27 WEST IRVING ST, CHEVY CHASE

[HP CASE # 35113-13F]

SUBJECT: Historic Area Work Permit #623794, for non-original window and siding replacement and other alterations

EXPEDITED
MONTGOMERY COUNTY HISTORIC PRESERVATION COMMISSION
STAFF REPORT

30

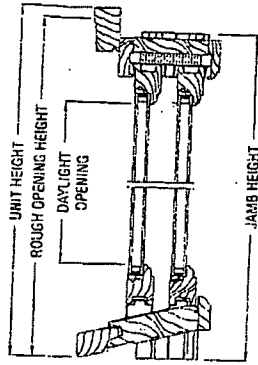
- Replace windows and doors in non-historic additions that are compatible with the original windows in the historic block. The proposed replacements are Weathershield wood SDL windows and doors (see circles 30-32).

33

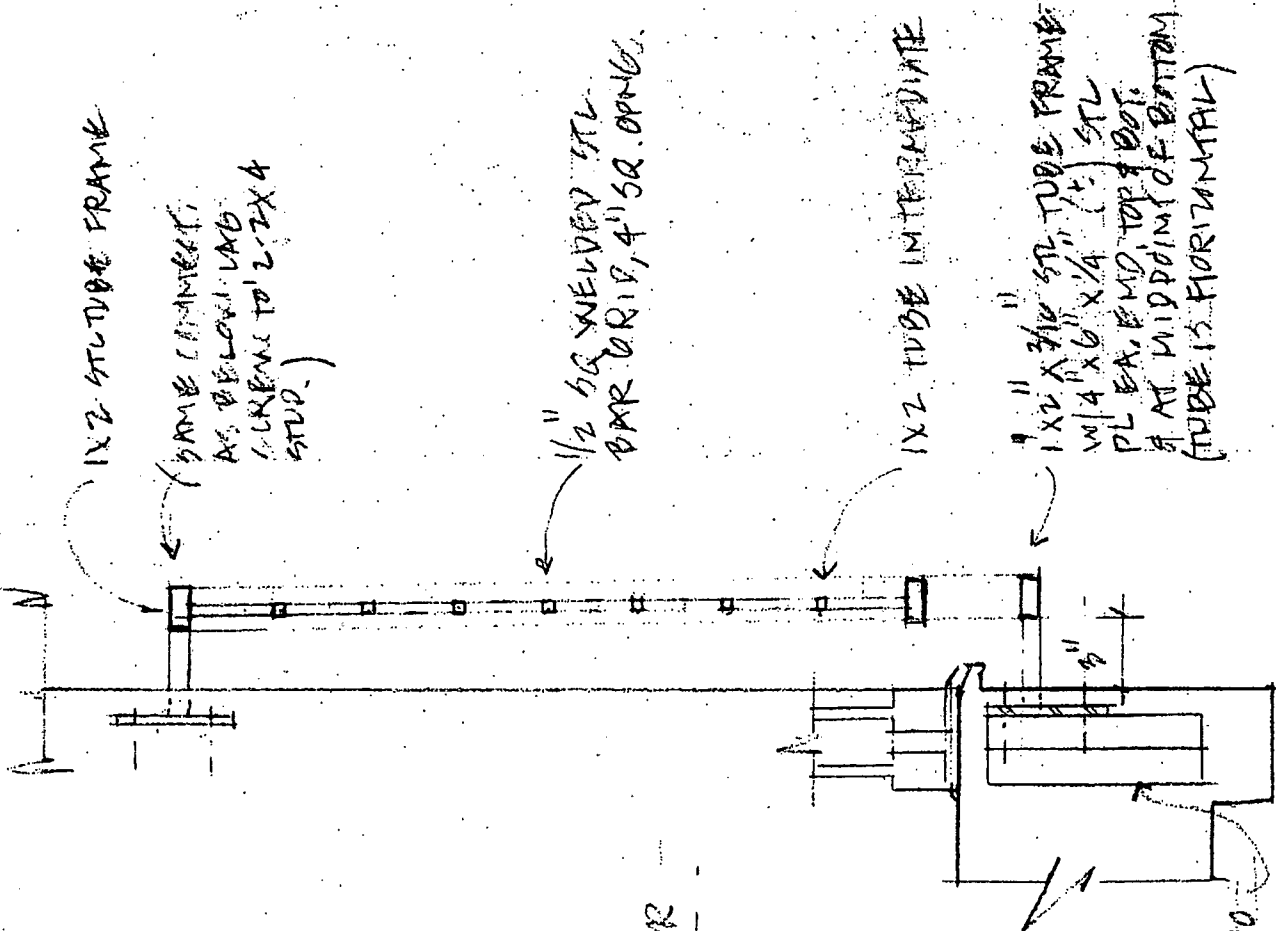
- Addition of welded iron rail on south (front) elevation, west (left) elevation, and rear (north) in non-historic addition. Detail specification sheet can be located at circle 33.
